IN THE MATTER OF SERVICE
QUALITY ISSUES, ANALYSIS OF
TRANSMISSION ALTERNATIVES AND
PROPOSED PLAN OF ACTION IN THE
SANTA CRUZ ELECTRIC DIVISION OF
CITIZENS UTILITIES COMPANY

NOTICE OF FILING
SURREBUTTAL OF MARSHALL
MAGRUDER

SURREBUTTAL

Appendix K – Surrebuttal Change to Magruder Testimony of 8 July 2005

Figure 1.2-4 Supply versus Demand for the Santa Cruz Grid with the Existing 115 kV Transmission Line. Each Substation is provided with an adequate supply from the Existing 115 kV Transmission Line, with a Significant Supply Margin at all substations.

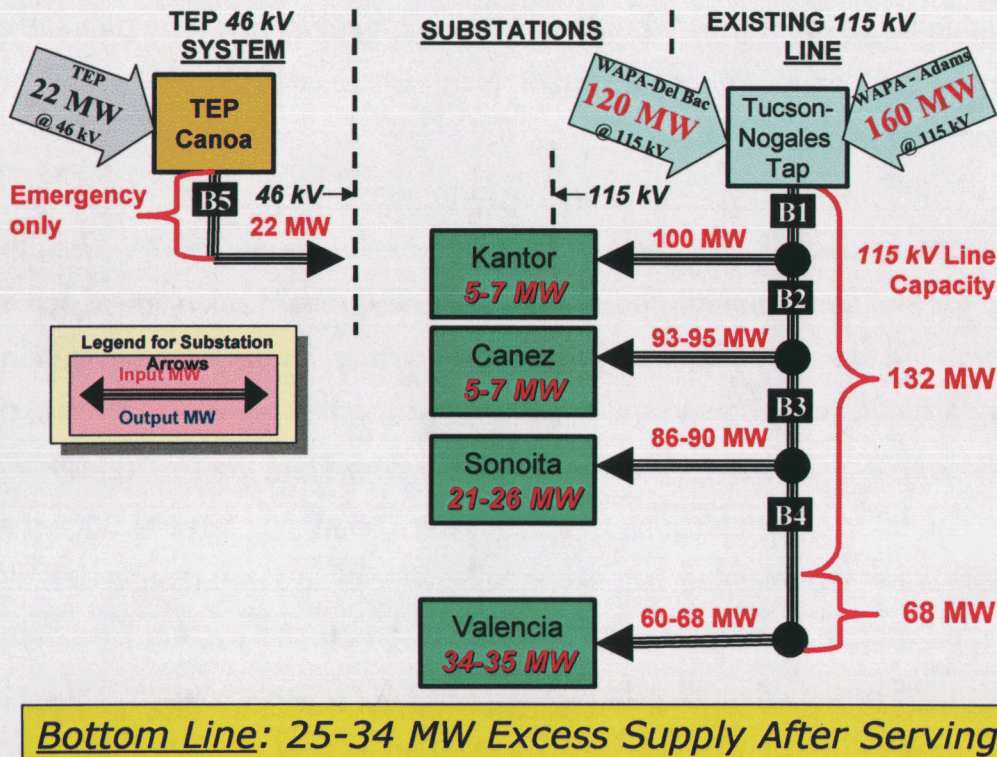
- 24
25 1. Background from Part I of the Magruder Testimony; however, Appendix K replaces
26 parts of section 1.2 including figure 1.2-4, which had some mathematical errors as
27 noted by the ACC Staff.
- 28 2. UniSource did not rebut Reliability in Santa Cruz Service Area in Part II. The ACC
29 Staff does not use this industrial reliability engineering design process and
30 apparently relies on Reliability Indexes (SAIFI, CAID, and SAIDI) – all after-power-
31 loss measures. The Mean Time Between Failure (MTBF) values were undisputed.
32 Other parties have not presented reliability design-oriented statistical data. The
33 engineering design process established that outages on distribution systems, from
34
35

- a. First Replacement: On the original page 20 at line 6 of the Magruder Testimony, please replace all through page 23 at line 27 with the below. First footnote is 12.

In Figure 1.2-4, we see the first substation, called Kantor, near Amado, that services the Northwestern part of Santa Cruz County including Mount Hopkins, will receive 100 MW. Based on Table 1.2-1, between 5 MW (Magruder estimate) and 7 MW (USNE estimate) of power will be necessary when peak power is 70 MW.¹³⁸

Thus, as shown in red in Figure 1.2-4, using UNSE's 7 MW, then between 95 MW (100-5) and 93 MW (100-7) are available for the next substation, called Canez for the north Rio Rico area, with a load of between 7 MW (from USNE) to 5 MW (from Magruder). From Canez, then 86 MW (93-7) to 90 MW (95-5) are available for the Sonoita substation, in south Rio Rico. From Canez, then 86 MW (93-7) to 90 MW (95-5) are available for the Sonoita substation, in south Rio Rico.

There still is 60 to 68 MW power remaining for Valencia Substation. This exceeds the peak Nogales load--34 MW to 35 MW -- by 25 to 34 M or between 71% and 100% (25/35 and 34/34). Therefore, under normal, no contingencies, conditions, each substation has excess power margins, including the last one. The distribution of customers and load for each substation is, of course, variable, so ranges provide reasonable estimates.

Figure 1.2-4 shows inside each rectangle representing a substation, the range of peak demand loads (for example, Valencia peak load is 34-35 MW), with the available supply for that substation (in red) from the 115 kV transmission line. Each substation's load reduces the available supply of power available for the next substation, thus, 60 to 68 MW are available to meet Valencia demands, which needs 34-35, and thus, an excess supply of 25-34 MW exists when the total system load is 70 MW.

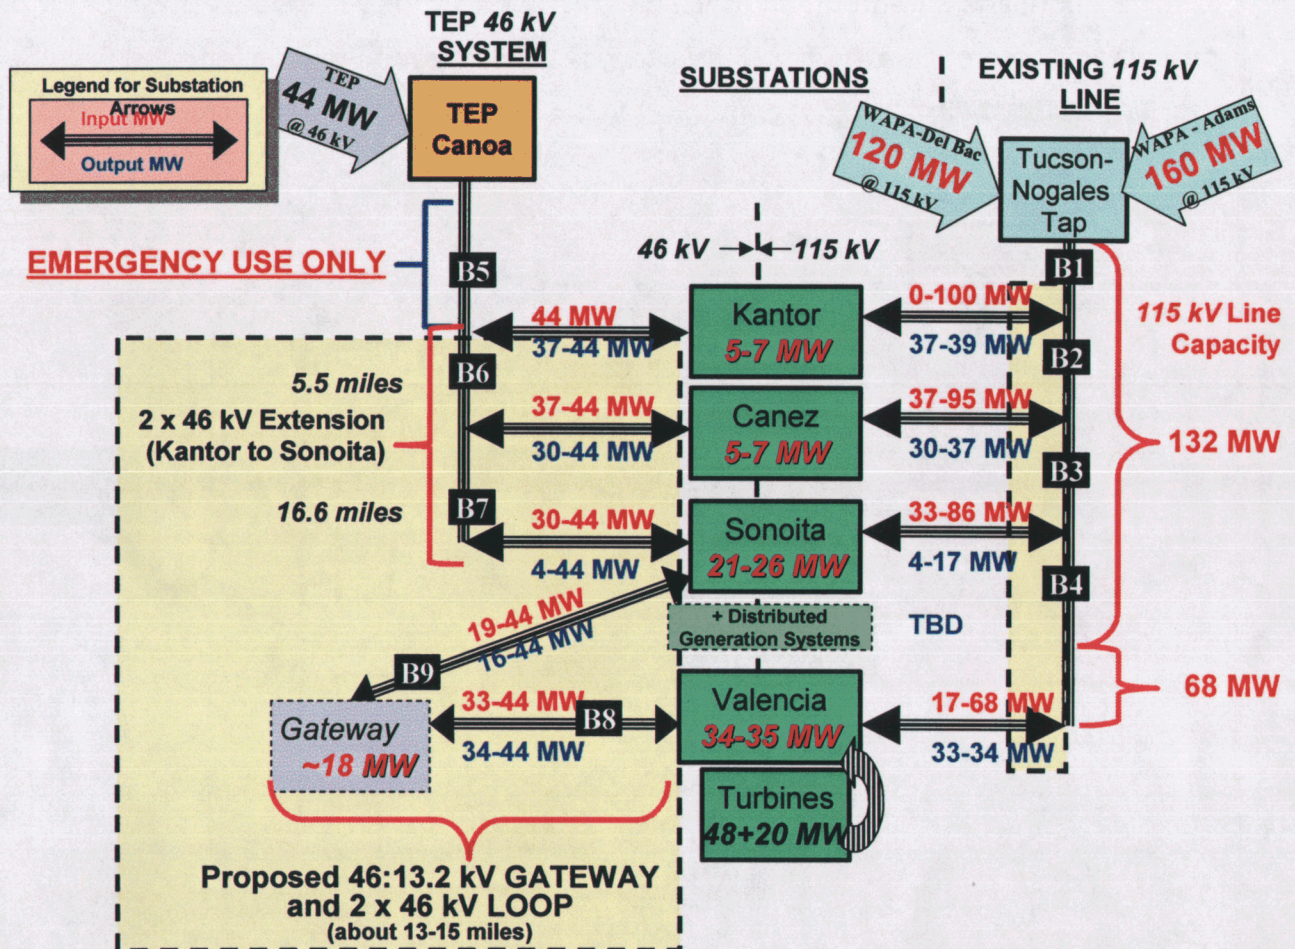
- 22 5. Proposed Second Transmission Line Alternatives from Part V. There was no
23 rebuttal to this section; however, upon review, Figure 5.4-3 was found to have
24 some mathematical errors now corrected in Appendix K.

Please insert the below in place of the existing Figure 5.4-3 and caption on the original page 67.
